ADDENDUM NUMBER TWO (2)

Project: Health Sciences Complex (Rankin Campus)
Hinds Community College
Pearl, MS
HCC Bid #3298
PN: 21041

FROM: Dean Architecture, P.A.
661 Sunnybrook Road, Suite 140
Ridgeland, MS 39157
(601) 939-7717

C2.2

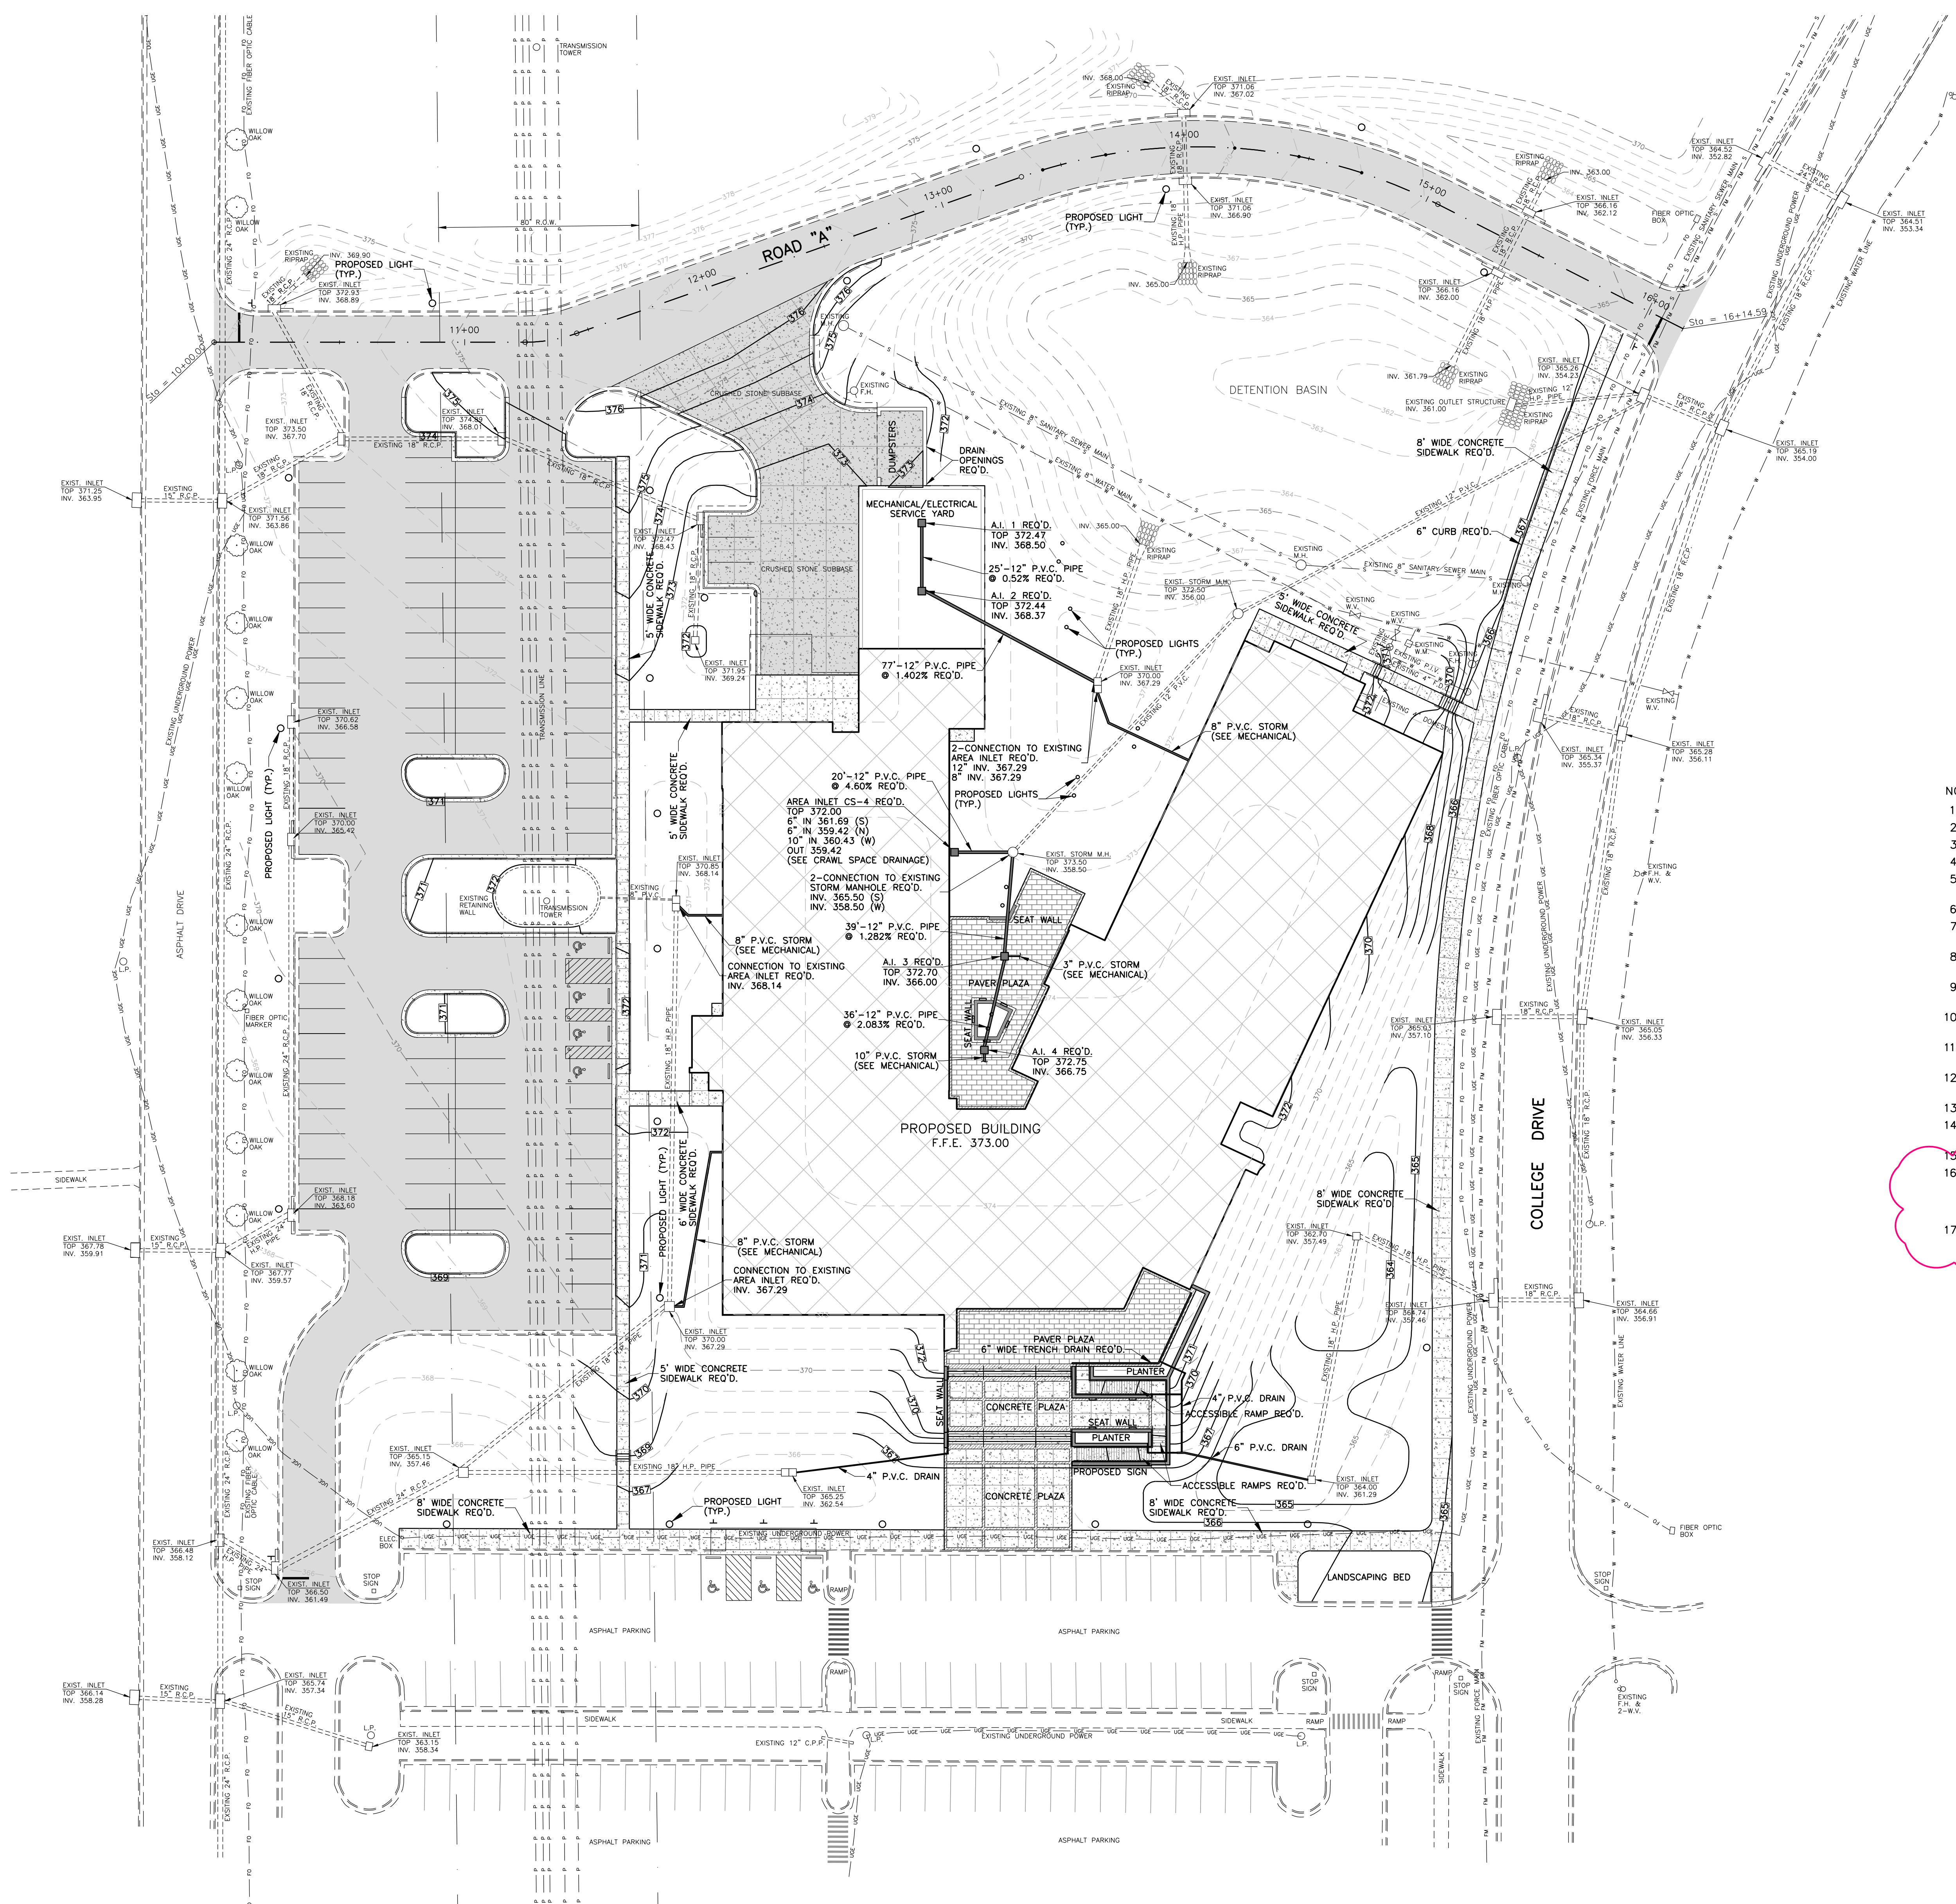
1.4 Item #2 – Revised sheet C2.2 Grading and Drainage. See attached.
